## **USACE Oroville WCM Update - Social Economic Concerns** (dated 3-2-26)

**Figure 3-3.** FIRO Space for ORO Reservoir.

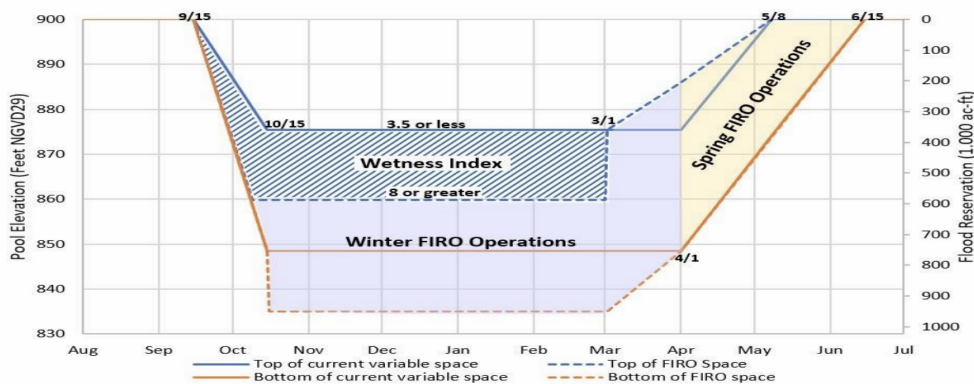
The FIRO Viability Analysis lists the 1986 storm scaled by 140% as a 1/346 yr event, (SPF x 70%) Auxiliary Spillway surcharged by 5 ft for 48 hrs and the Yuba City levees overtopped for 4 days. The only constraint that was met was to not drop the FIRO Space below the current 835 ft. elev.

### **Concern 2) Remove the Elev. 835' Hard Bottom / Replace with Conservation Pool Recovery**

If risk to conservation pool recovery is minimized, using a Hard Bottom constraint is irrelevant.
